Approved Section 4.55 (2) Modification Application

No: SSD 6966 MOD 1 Granted on 19 August 2021

ONE SYDNEY HARBOUR

BARANGAROO

1 Podium facade detail - Elevation
1 : 25

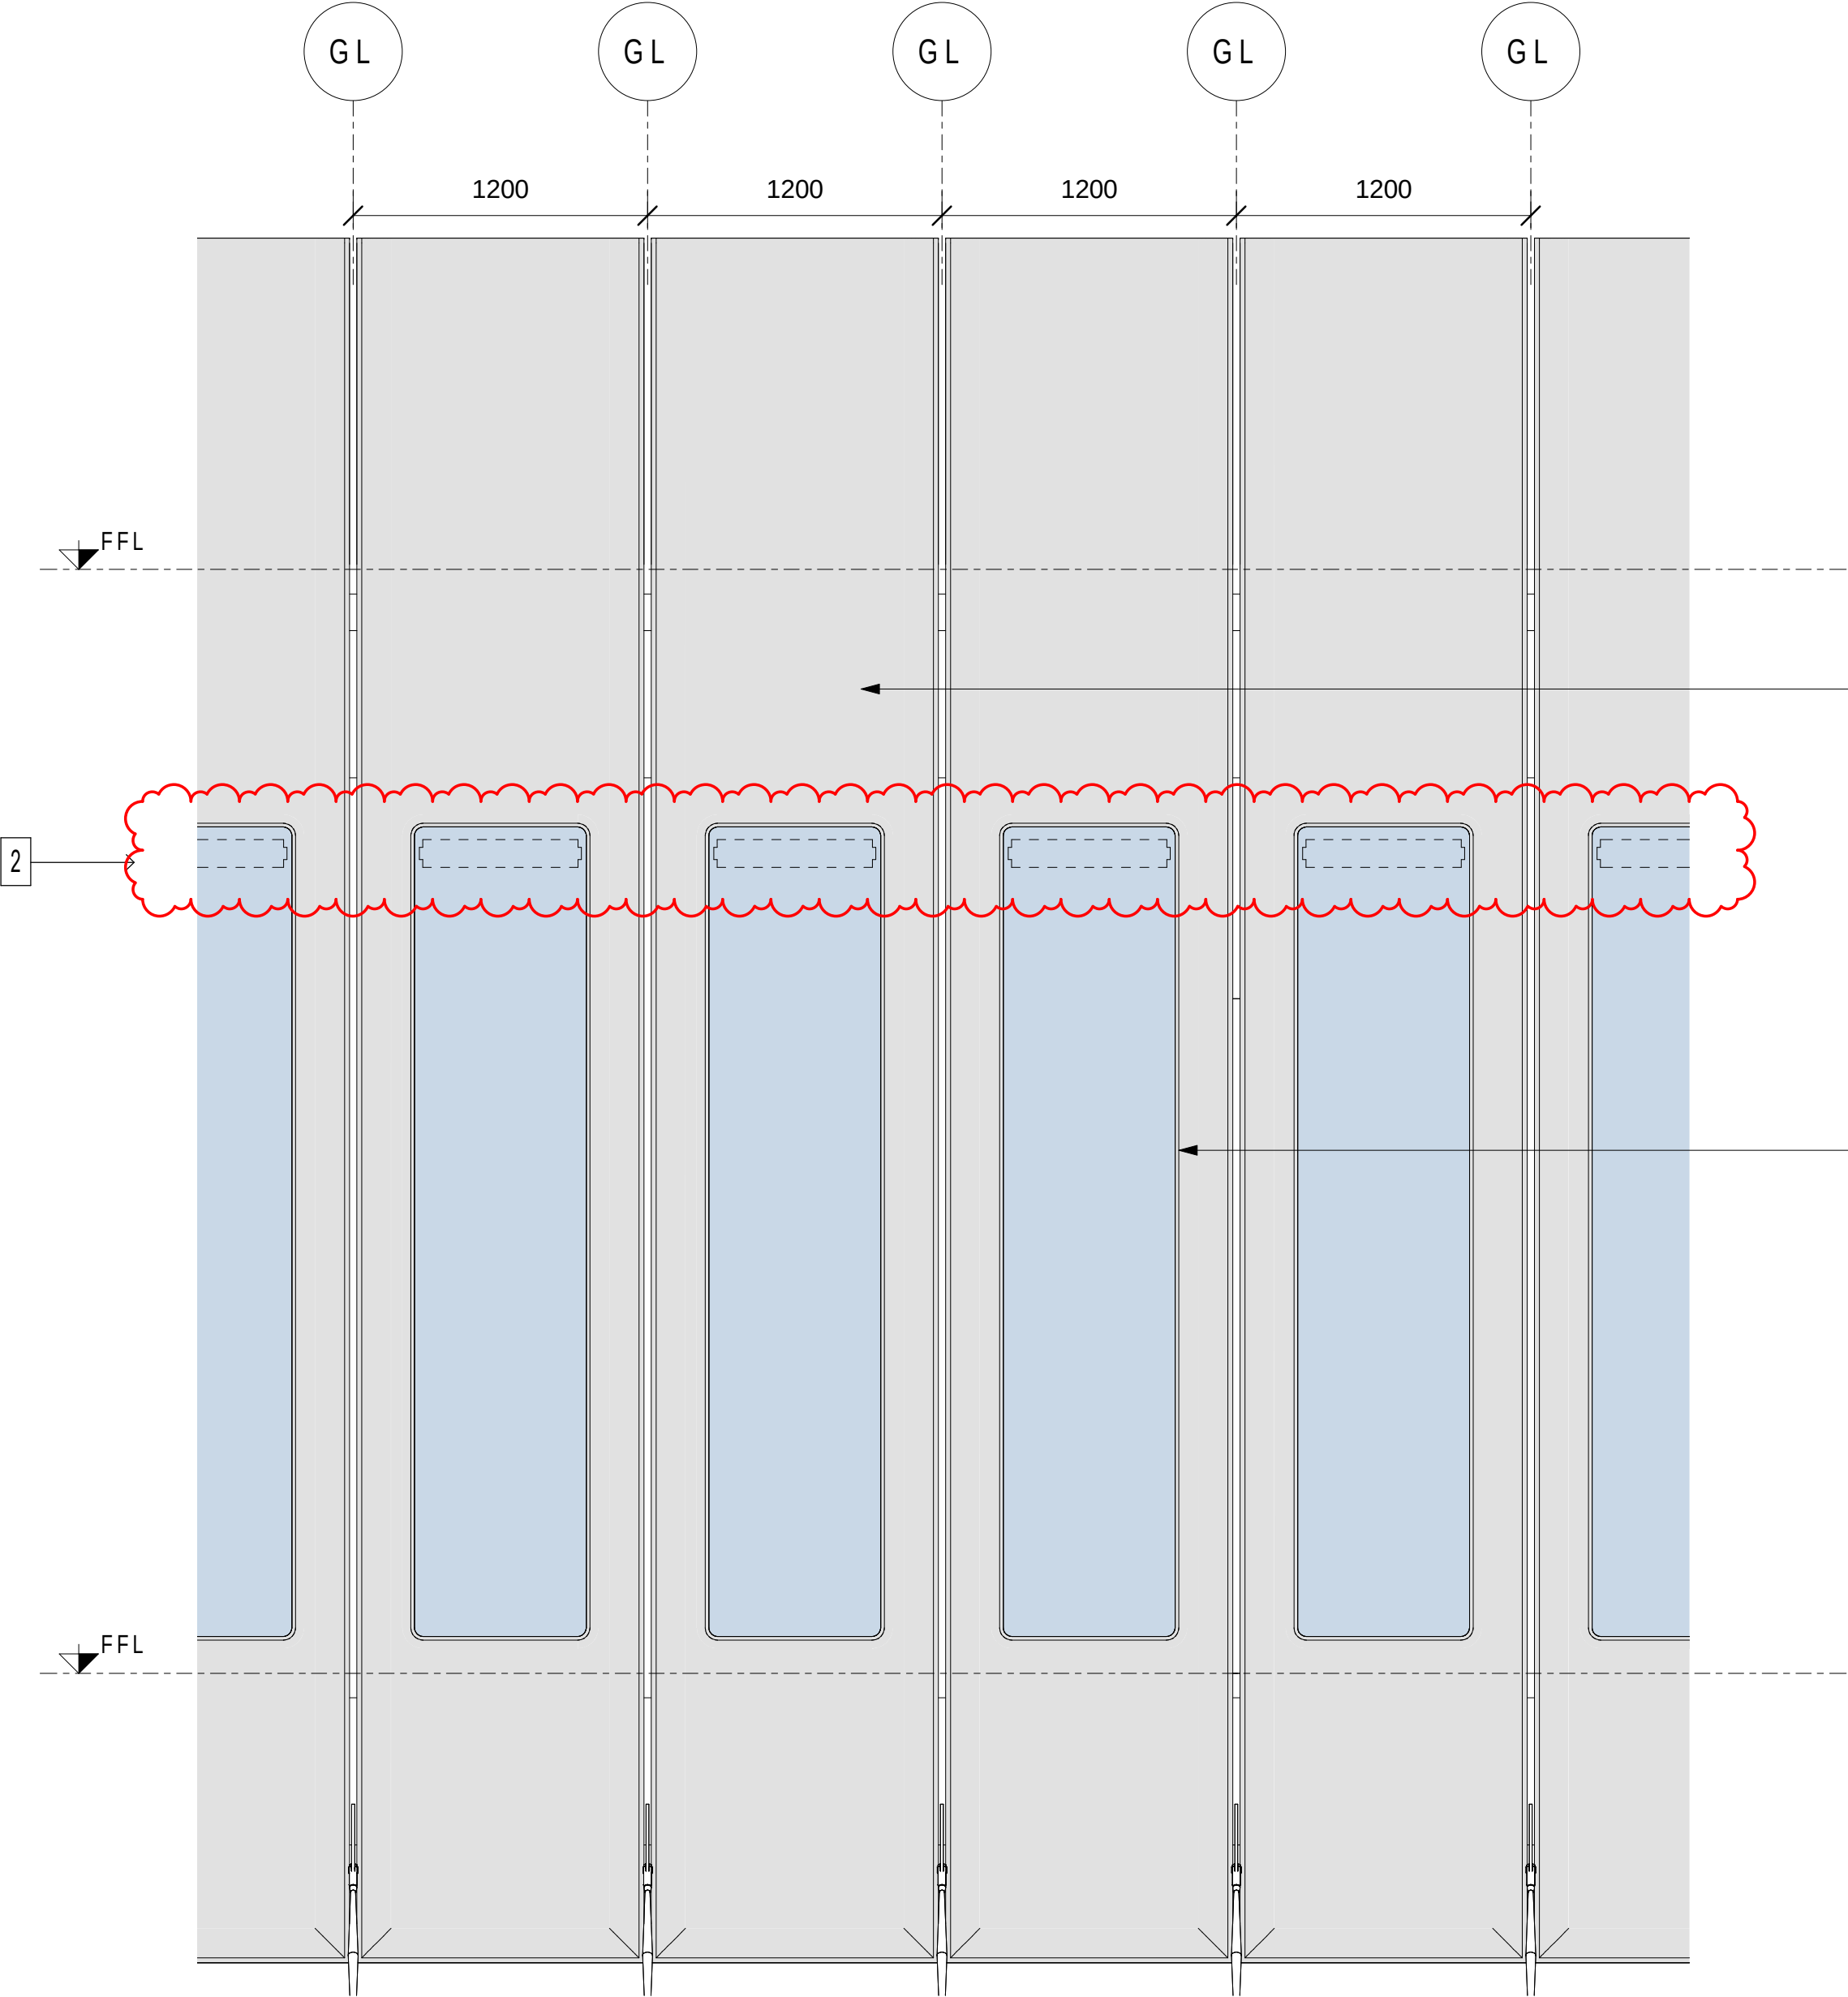
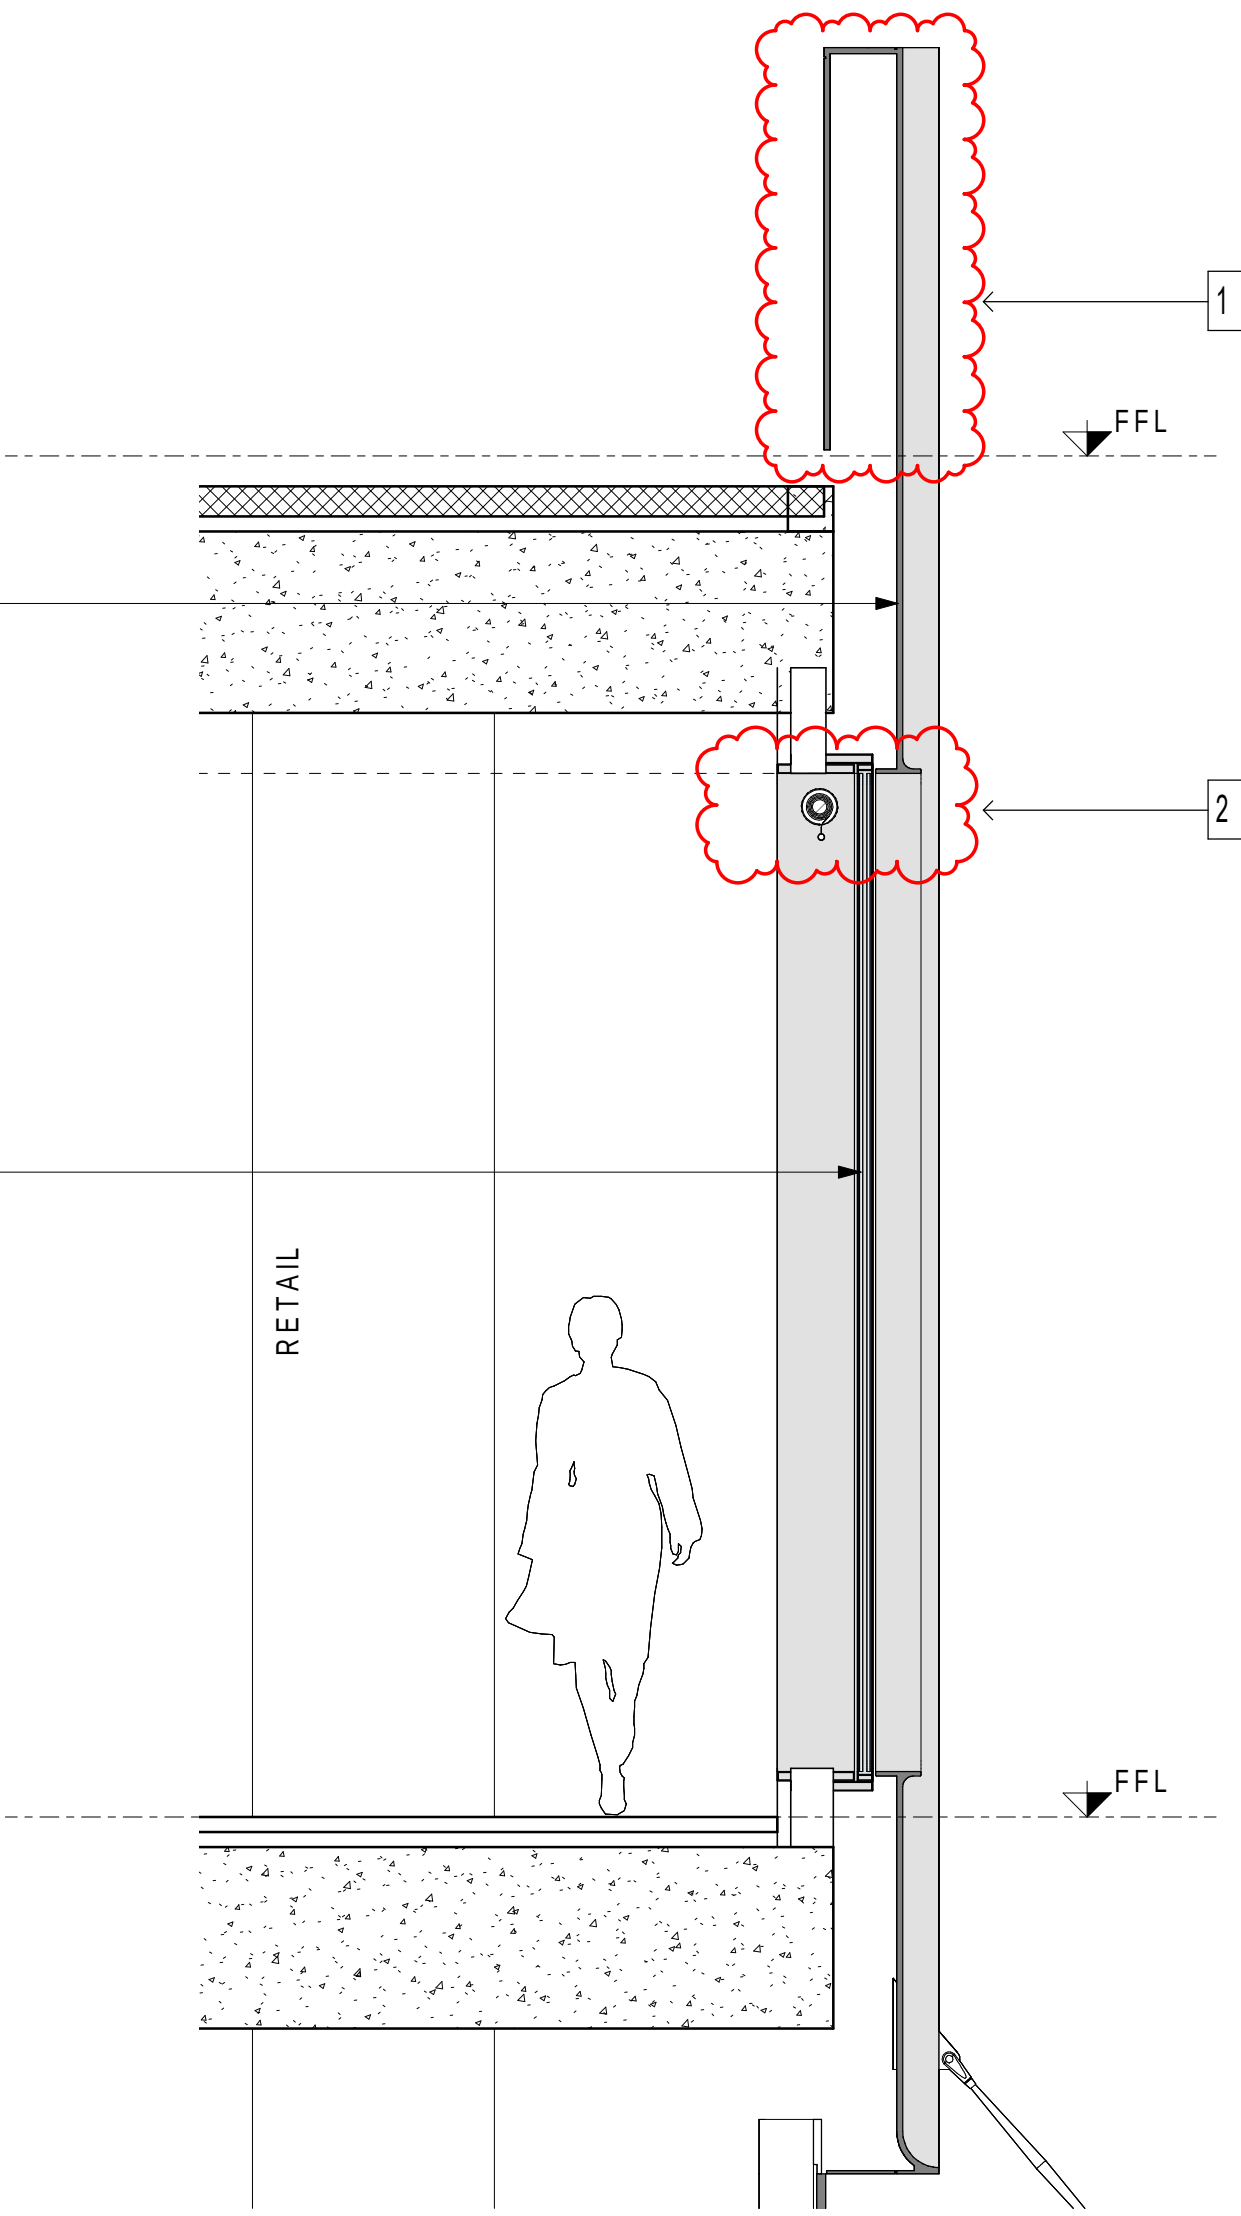
MODIFICATION:
1. UPDATED GRC PANEL TOP
2. SHIFTED ROLLER BLINDS FROM OUTSIDE TO INSIDE
